Access Compliance Report

Public Rights-of-Way

Intersection ID: 28674	Main Street: ARBORHILL_RD	Cross Street: WINTHROP RIDGE_RD	Location: SW
ADA ID: 5BB9727411CA	Ramp Type: Perp	Initial Pass/Fail: Fail	Overall Compliance: No
		Severity Score: 30

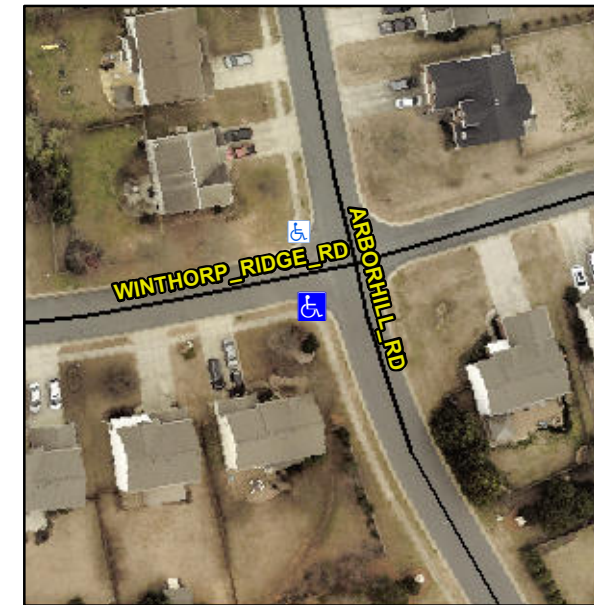
Not Found, R304.5.1, R304.5.3

Compliance	Description	Data	Compliance	Description	Data
N/A	Ramp Length (in)	48.0	Yes	Ramp Slope (%)	5.0
No	Ramp Width (in)	35.0	No	Ramp XSlope (%)	6.0
N/A	Flare Type LT	N/A	N/A	Flare Type RT	N/A
N/A	Flare Slope LT (%)	N/A	N/A	Flare Slope RT (%)	N/A
N/A	Flare Traversable LT?	N/A	N/A	Flare Traversable RT?	N/A
N/A	Landing Length (in)	N/A	N/A	DWS Provided?	N/A
N/A	Landing Width (in)	N/A	N/A	DWS Contrast?	N/A
N/A	Landing Slope (%)	N/A	N/A	DWS Length (in)	N/A
N/A	Landing X Slope (%)	N/A	N/A	DWS Full Width?	N/A
N/A	Landing Curb? (Y/N)	N/A	N/A	DWS Offset (in)	N/A
N/A	Shared Landing?	N/A			
N/A	Gutter Ponding?	N/A	N/A	Gutter Slope (%)	N/A
N/A	Gutter Lip Ht (in)	N/A	N/A	Gutter X Slope (%)	N/A
N/A	Painted X Walk1?	No	N/A	Painted X Walk2?	N/A
	X Walk 1 Direction	To N		X Walk 2 Direction	N/A
N/A	X Walk 1 Width (in)	N/A	N/A	X Walk 2 Width (in)	N/A
	X Walk 1 Slope (%)	0.5		X Walk 2 Slope (%)	N/A
	X Walk 1 X Slope (%)	3.6		X Walk 2 X Slope (%)	N/A

Remove & Replace Entire Ramp.
